AGENDA
DANIA BEACH CITY COMMISSION
REGULAR MEETING
MONDAY, DECEMBER 11, 2017 - 7:00 PM

- 1. Dania Beach Marina Restroom Renovation Design - Public Services and Cartaya and Associates Architects, P.A.

SITE PLAN DETAILS/ZONING PLAN

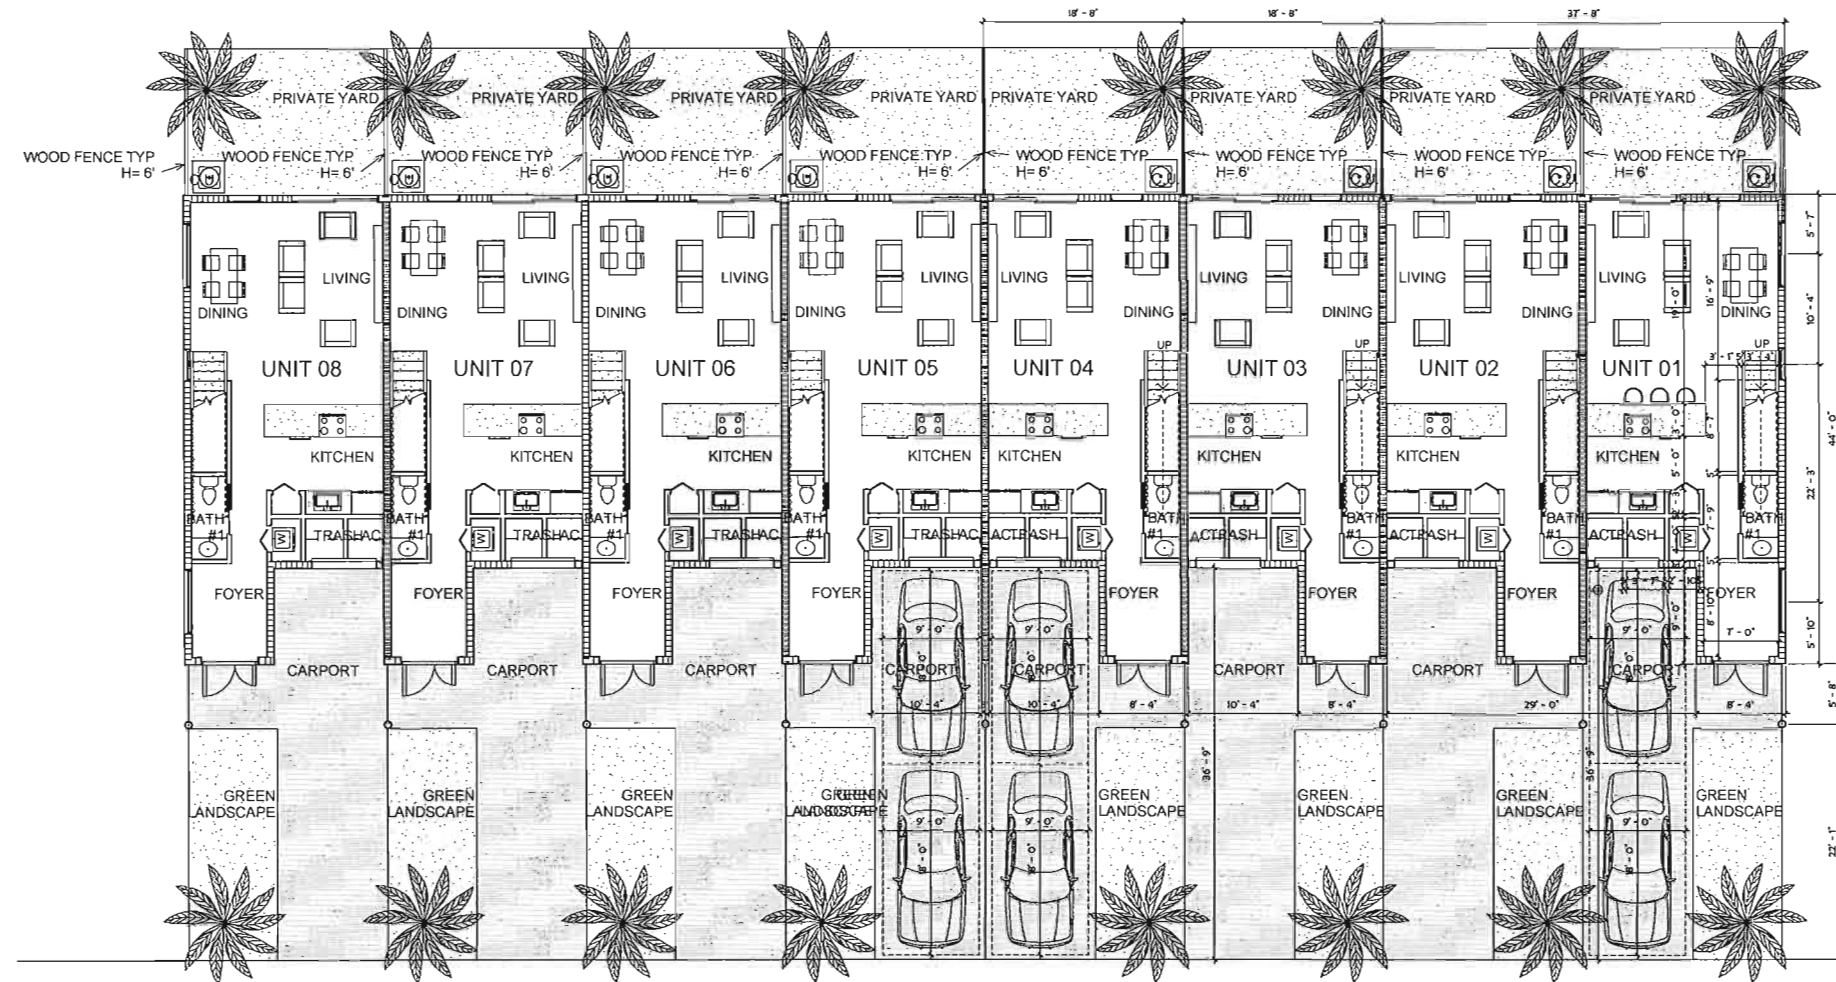
7. **USE:** Sheet A1.3. "Site Data" table and parking calculations identifies 63 townhouse units, but table "Unit/Building Breakdown" identifies 61 townhouse units. Revise accordingly.

15. Sheet A1.3 correct required minimum pervious area to be 37% as required in Section 215-130.
 16. Sheet A1.3, Clarify "Landscape Open Space" provided calculation.

R: Sheet A1.3 is now 1.2 min pervious corrected.

SHEET TITLE
EROSION &
SEDIMENT
CONTROL
PLAN
C2 of 1

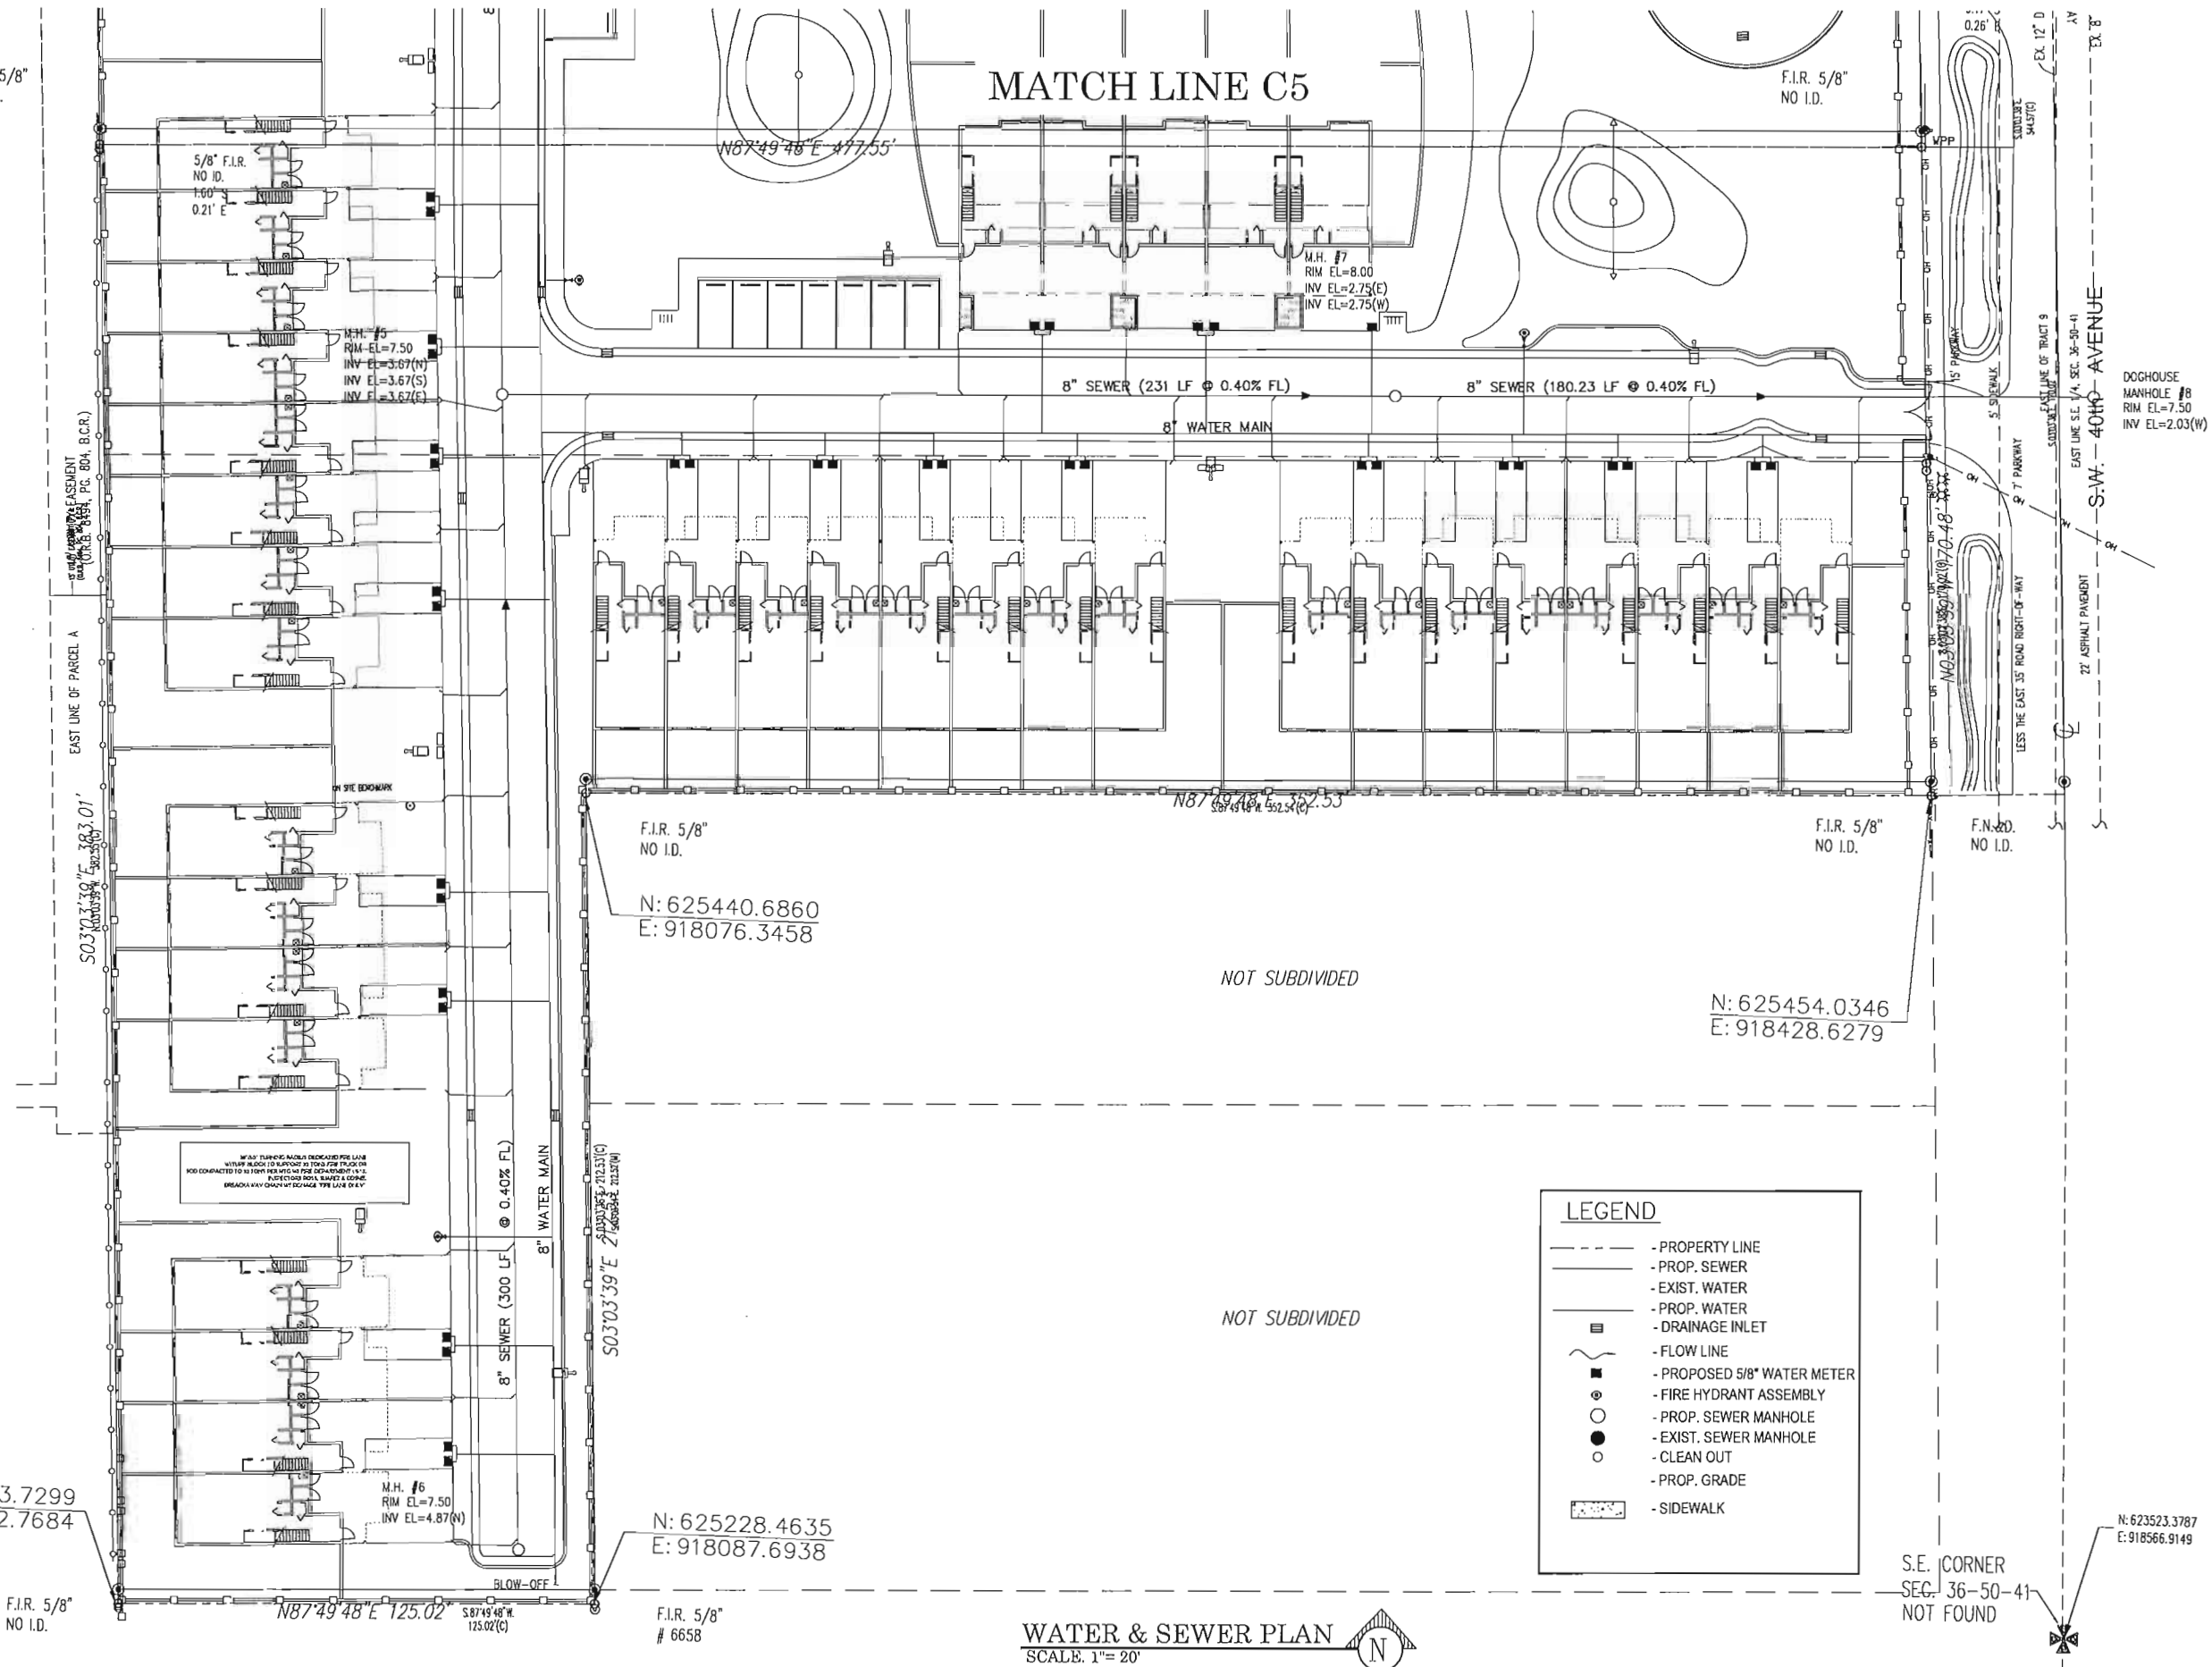
1. Fire Department Access Information as follows:
 - a. All turning radii (demonstrated)
 - b. Fire Department Apparatus Access Road locations and dimensions - demonstrate or note on the plan how they will be marked and delineated on site.
2. Water Supply Information as follows:
 - a. Dimensions of the three nearest adjacent hydrants to the project site
 - b. Please provide a legend on the Water & Sewer sheet C2 showing hydrant symbols.
 - c. Show Point of Service.

R: a. Dimensions have been provided for the three nearest adjacent hydrants to the project site, see Sheet C5.

Sheet
A2.01

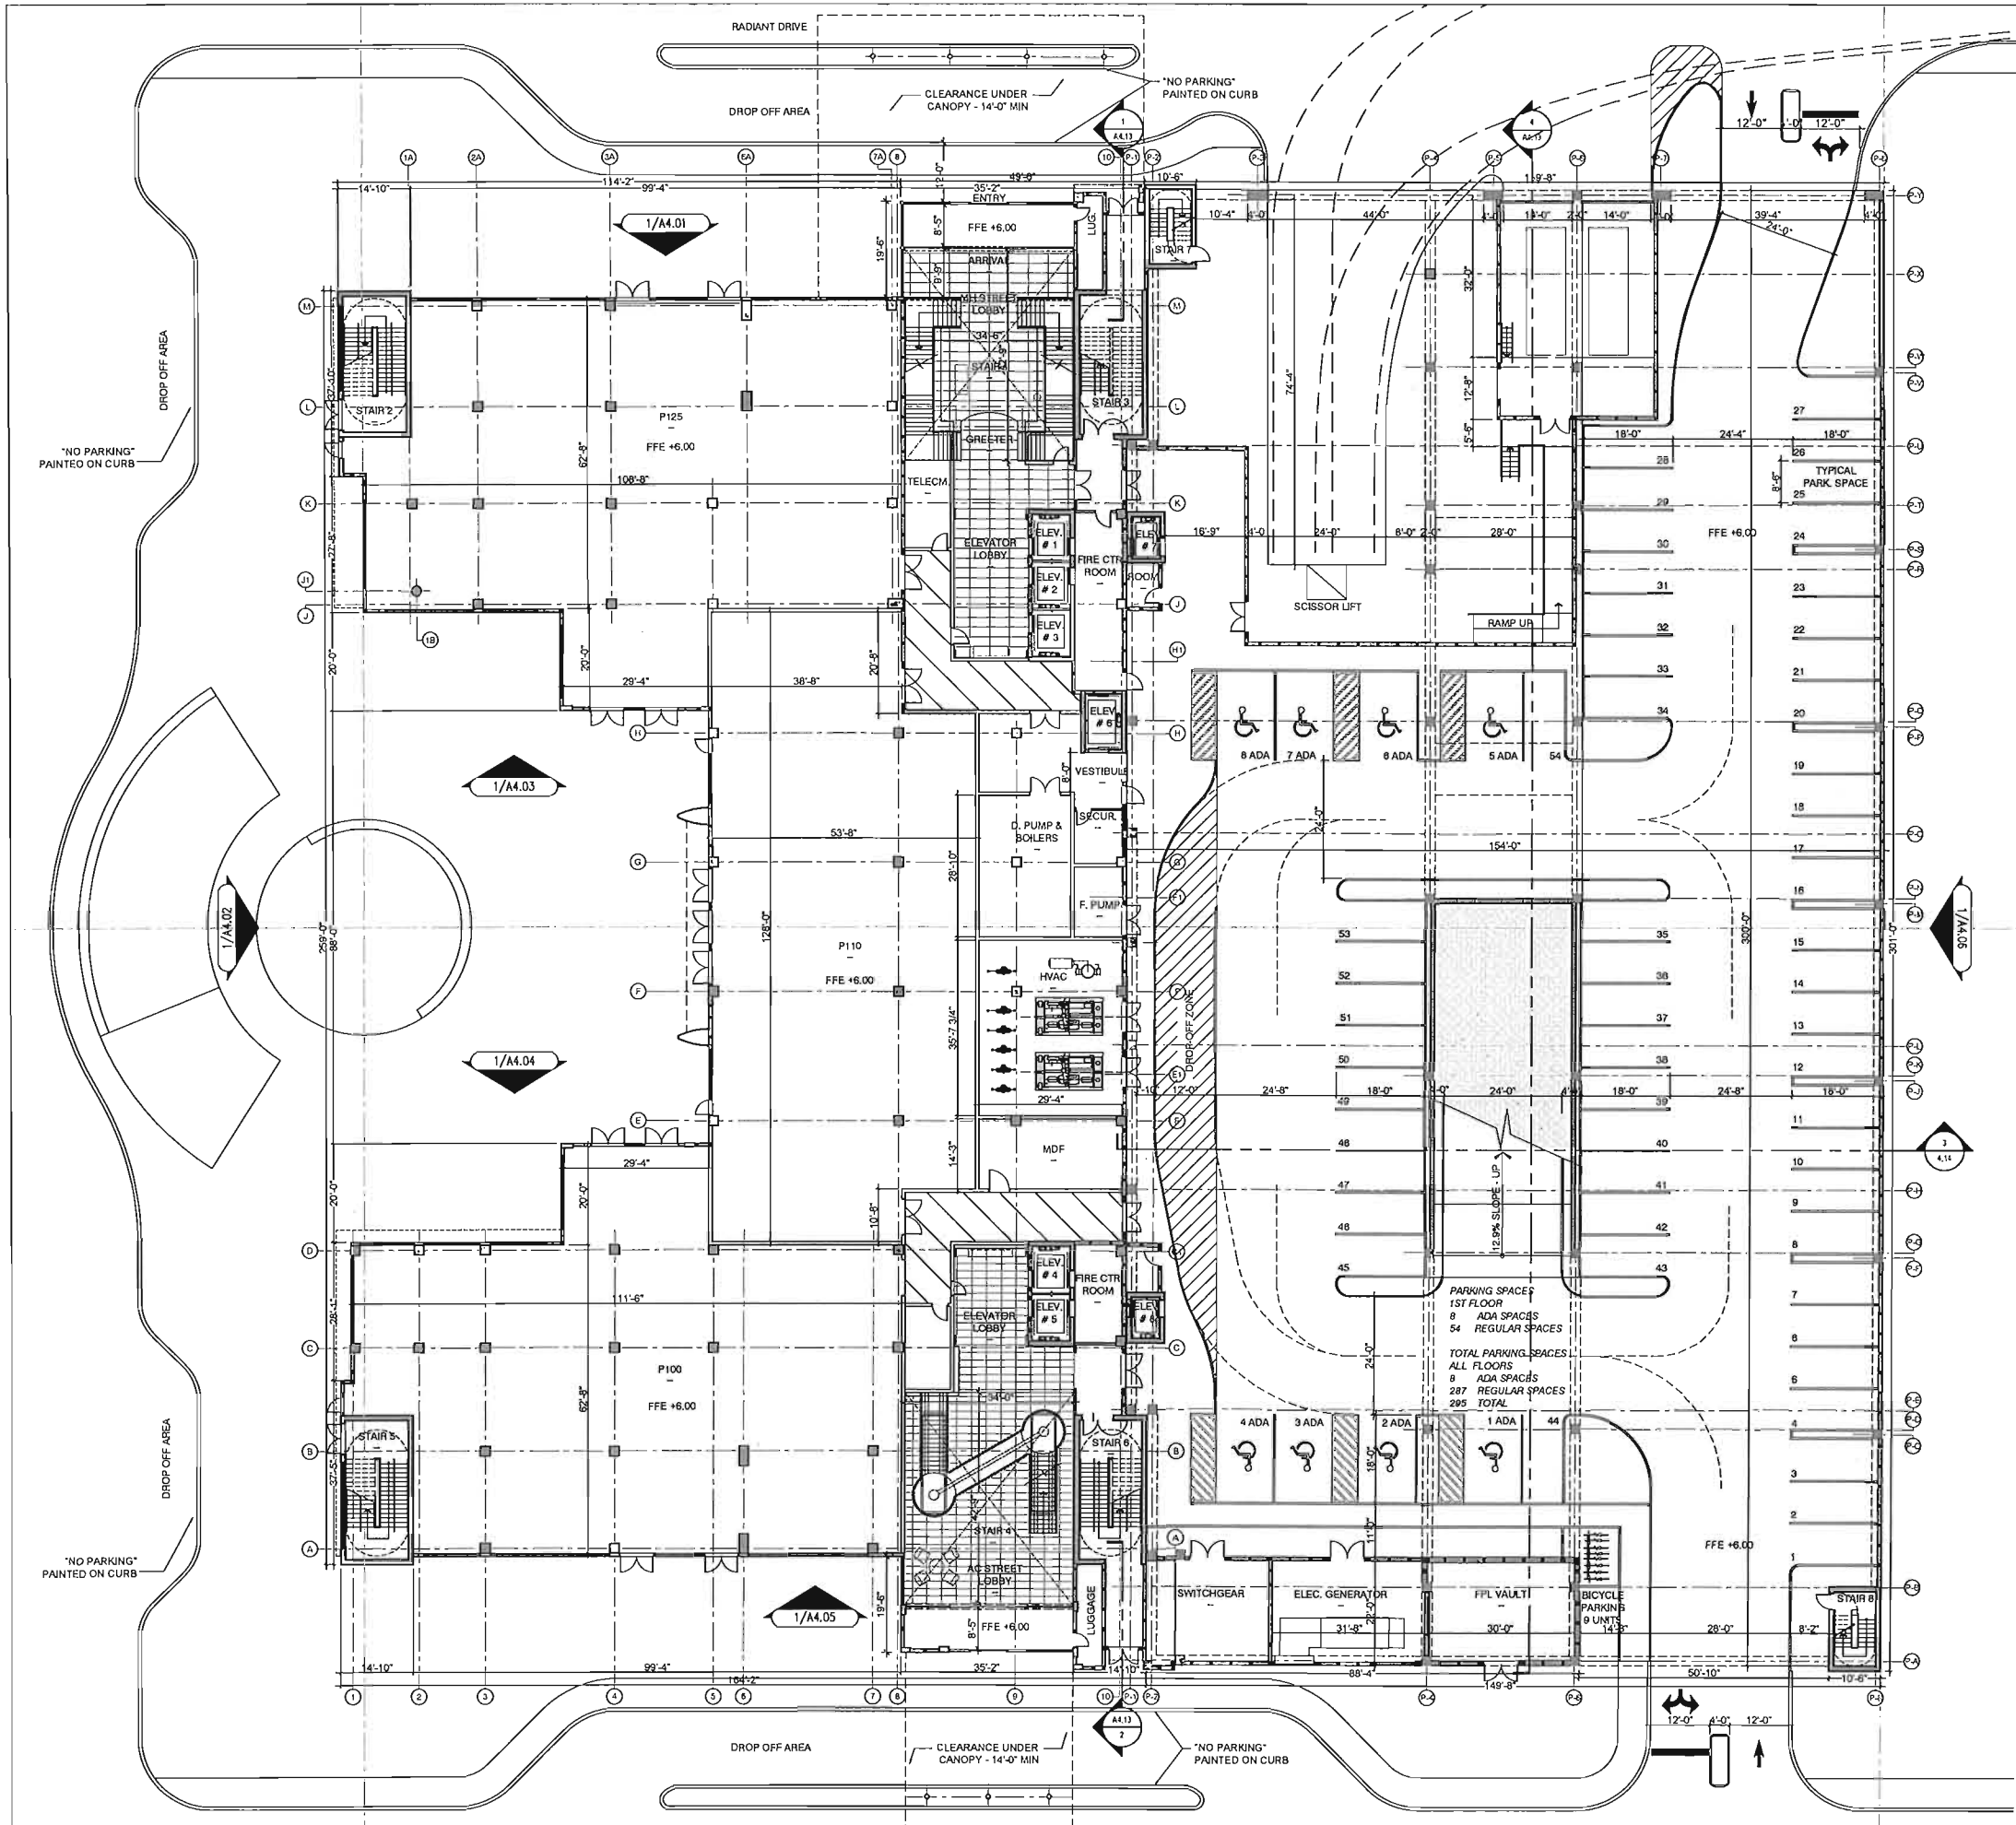
19. Sheet A2.01: Please revise ground floor plan to show proposed Finished Floor Elevations (Flood Plain Reviewer).
 20. "Sector" sheets A3.01, A3.1, A3.21, A3.33 could not be located (Flood Plain Reviewer).
